HISTORIC AND DESIGN REVIEW COMMISSION

February 20, 2019

HDRC CASE NO: 2018-585
ADDRESS: 1500 N ST MARYS
405 W JONES AVE
LEGAL DESCRIPTION: NCB 997 BLK G LOT 1A 2A B2
NCB 997 BLK G LOT E 126.2 FT. OF C OR A-14 & A-15
ZONING: FBZ T5-1, RIO-2
CITY COUNCIL DIST.: 1
APPLICANT: Xavier Gonzalez/GRG Architecture
OWNER: Alamo Community Group
TYPE OF WORK: Construction of a five story, multi-family residential structure
APPLICATION RECEIVED: February 01, 2019
60-DAY REVIEW: April 02, 2019
REQUEST:

The applicant is requesting a Certificate of Appropriateness for approval to construct a five story, multi-family residential structure to feature ground floor retail and internal, structured parking.

JONES AVE. ELEVATION

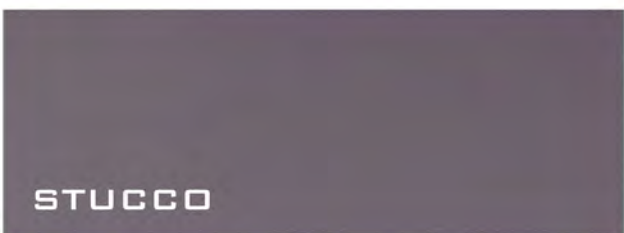
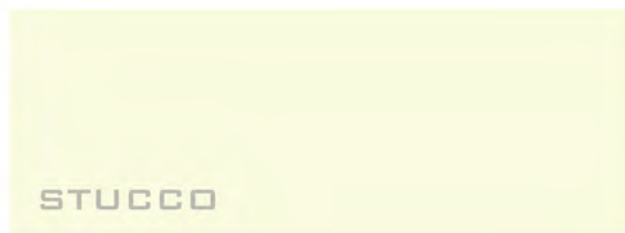
COMMENTS/CONCERNS: XG: OVERVIEW OF CHANGES TO DESIGN
SINCE CONCEPTUAL APPROVAL. JW: OVERVIEW OF DESIGN OBJECTIVES
OF THE ALAMO COMMUNITY GROUP. MG: QUESTIONS REGARDING PEDESTRIAN
ACCESS TO THE GARAGE. ALL: DISCUSSION REGARDING CORNER PROFILE
AND DETAILING. XG: QUESTIONS REGARDING PROPOSED BRICK
COLOR. JE: REINFORCE CORNER DESIGN, CONSIDER ELEMENTS TO LIVEN
BACK CORNER (MURAL, TILE, ETC.).
